Re: Revised Structural Observation — *101 North 12th Street, Erwin, NC 28339*

At your request, on October 29, 2025 we performed an on-site visual inspection and review of the structural plan proposed by *Tar Heel Basement Systems* for the first-floor framing reinforcement work at the Erwin residence noted above. The structure is a conventionally framed, detached, single family residence with raised first floor framing over a pier/curtain wall foundation system (see *picture 1*). Our observations are listed below. Indicators such as "left," "right," "front," and "back" are

R1 referenced as viewing the front of the home. This report has been revised to include a repair schematic which was initially omitted.

Picture 6 – Deteriorated joist

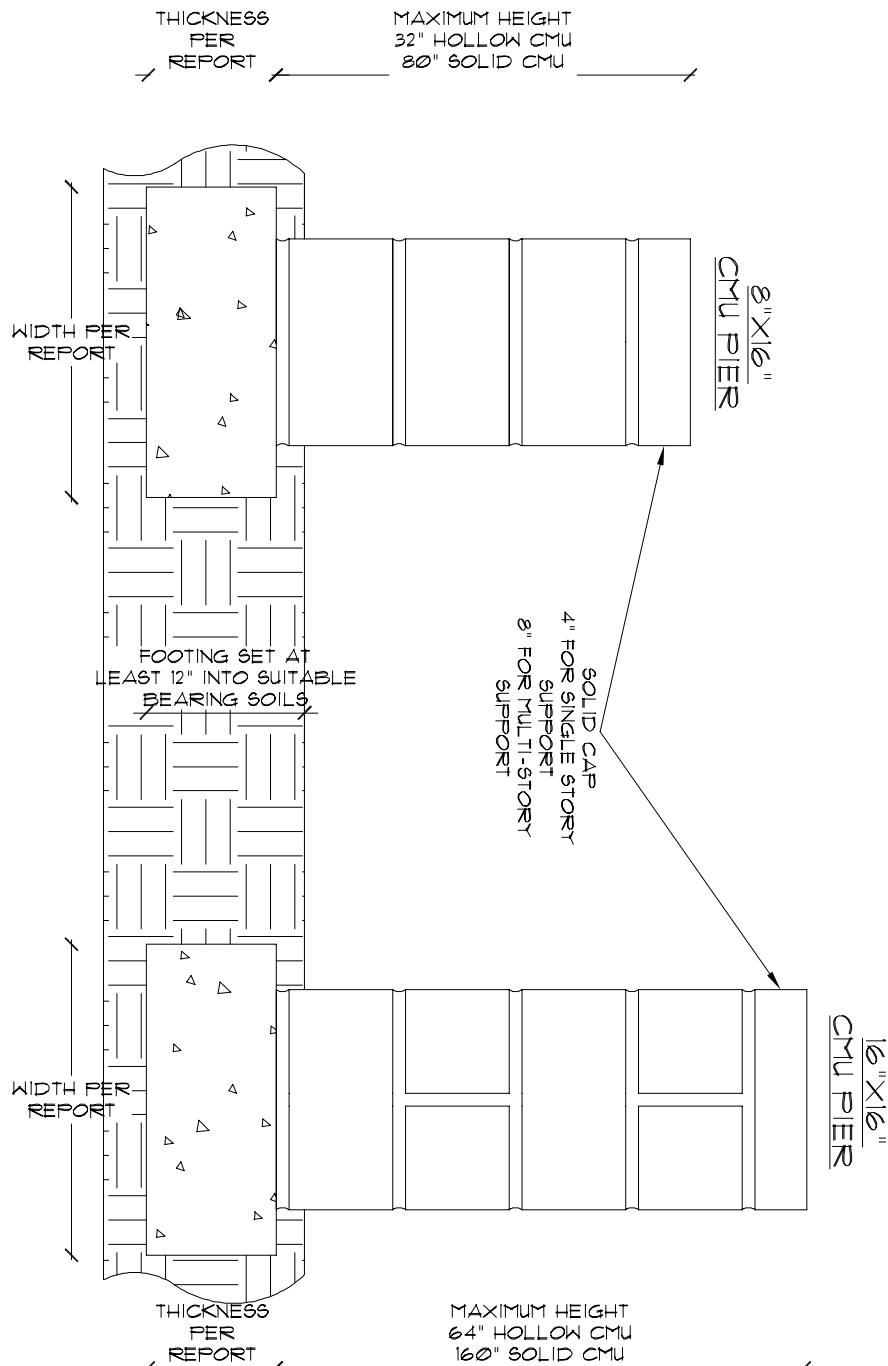
- Limited investigation from the crawlspace revealed the 5th-7th joists from the right were deteriorated (see *pictures 5-6 for examples*).
 - Measurement by laser level indicated the floor joists were sagging by as much as approximately 1 $\frac{3}{8}$ " at midspan.

- 2) Reinforce the back most girder bay at midspan using an IntelliJack support on a well-compacted 18"x18"x18" gravel footing (see *Detail 2*).
- 3) Reinforce each of the deteriorated joists noted above with an additional ply of full-depth (2x8 minimum) 2x #2 Southern Yellow Pine (SYP), fastened to the side of the deteriorated joists using (3)10d common nails at each end and at 12" on-center staggered top and bottom along the lengths of the joists. Sistered material should span continuously between end supports.

Picture 8 – Deteriorated joists past inadequate clearance

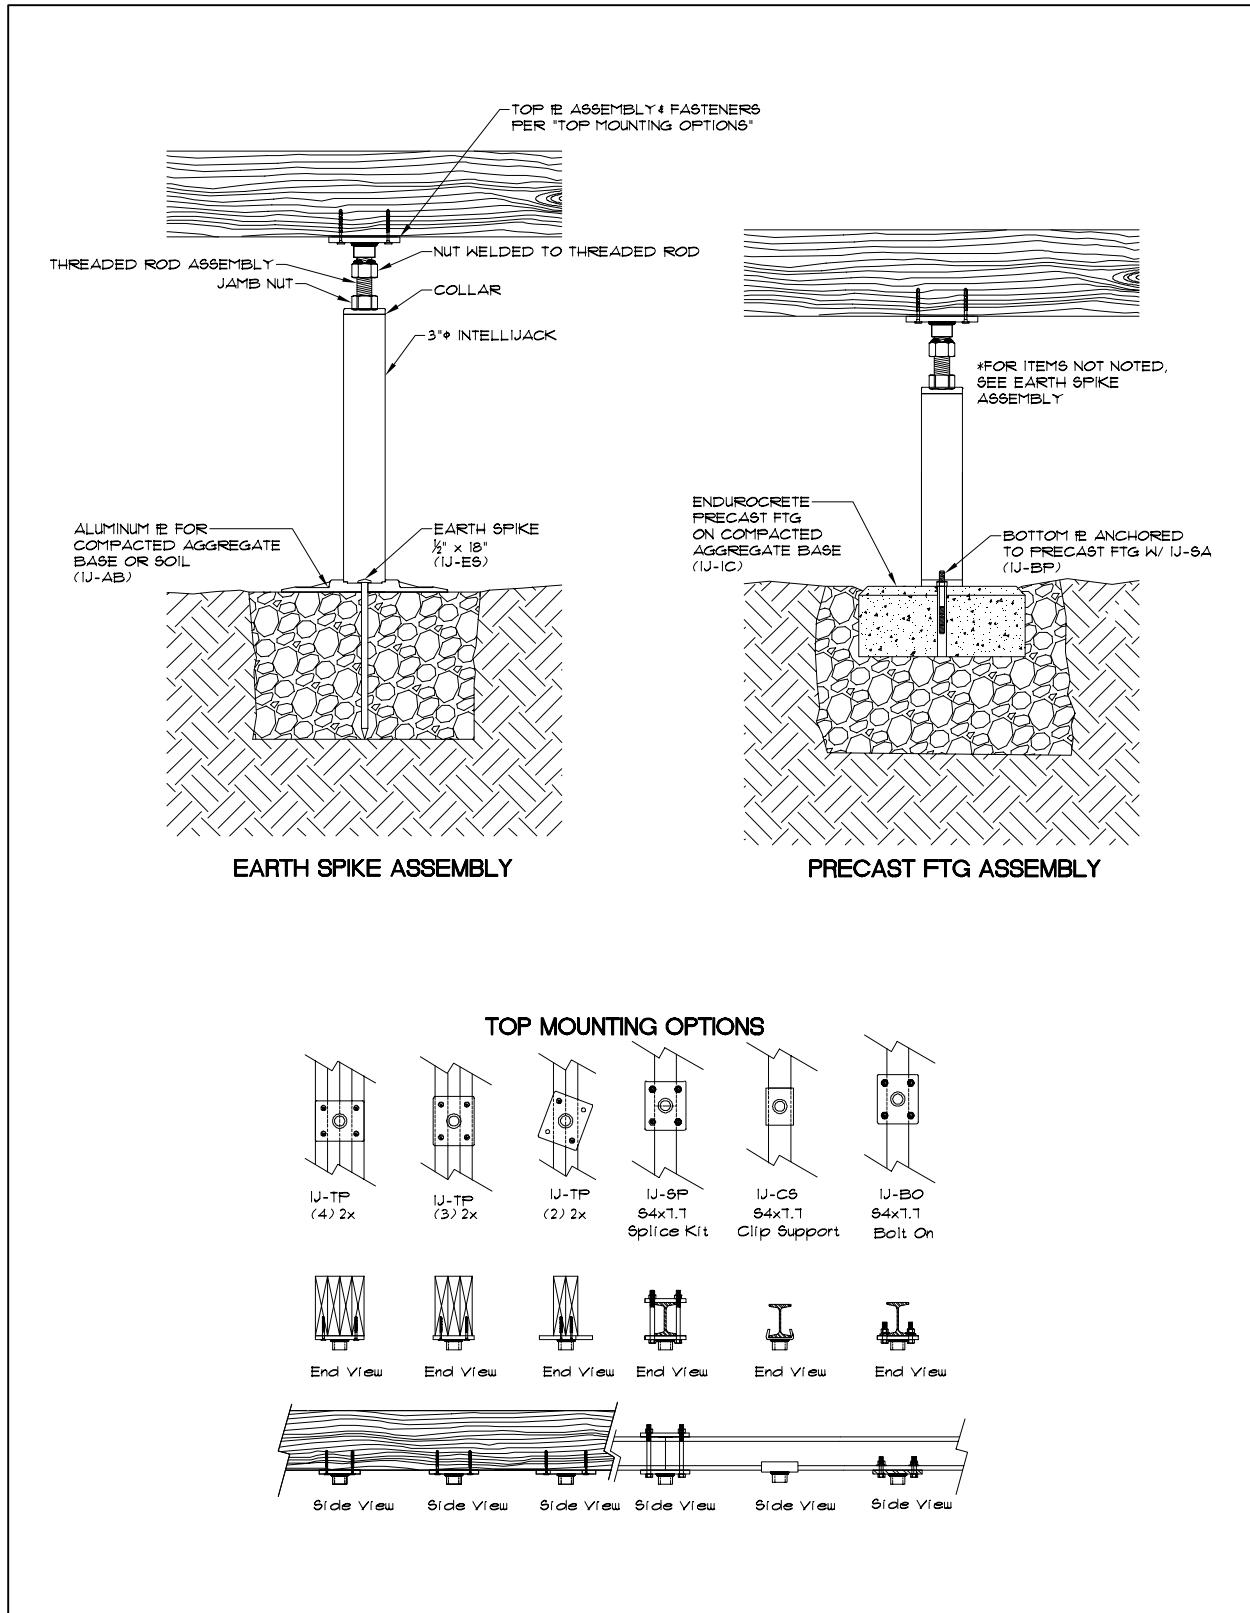
- Significant slopes in the floor were noted near the back bathroom as well as the left side of the home (see *picture 7 for example*).
 - As noted above, the framing beneath these areas was inaccessible at the time of our site visit; however, significant deterioration was visually apparent (see *picture 8*).

- a) If excavation is not to be performed, any new framing material should be treated #2 SYP in areas where minimum clearances are not met.
- 6) We strongly advise additional investigation be performed including the select removal of finishes in the portions of the home that are significantly uneven.

- a) *Additional structural repairs, up-to and potentially including, re-framing may be required. The removal of finishes to expose the existing framing configuration and the extents of deterioration are required in order to facilitate design of the appropriate repairs.*
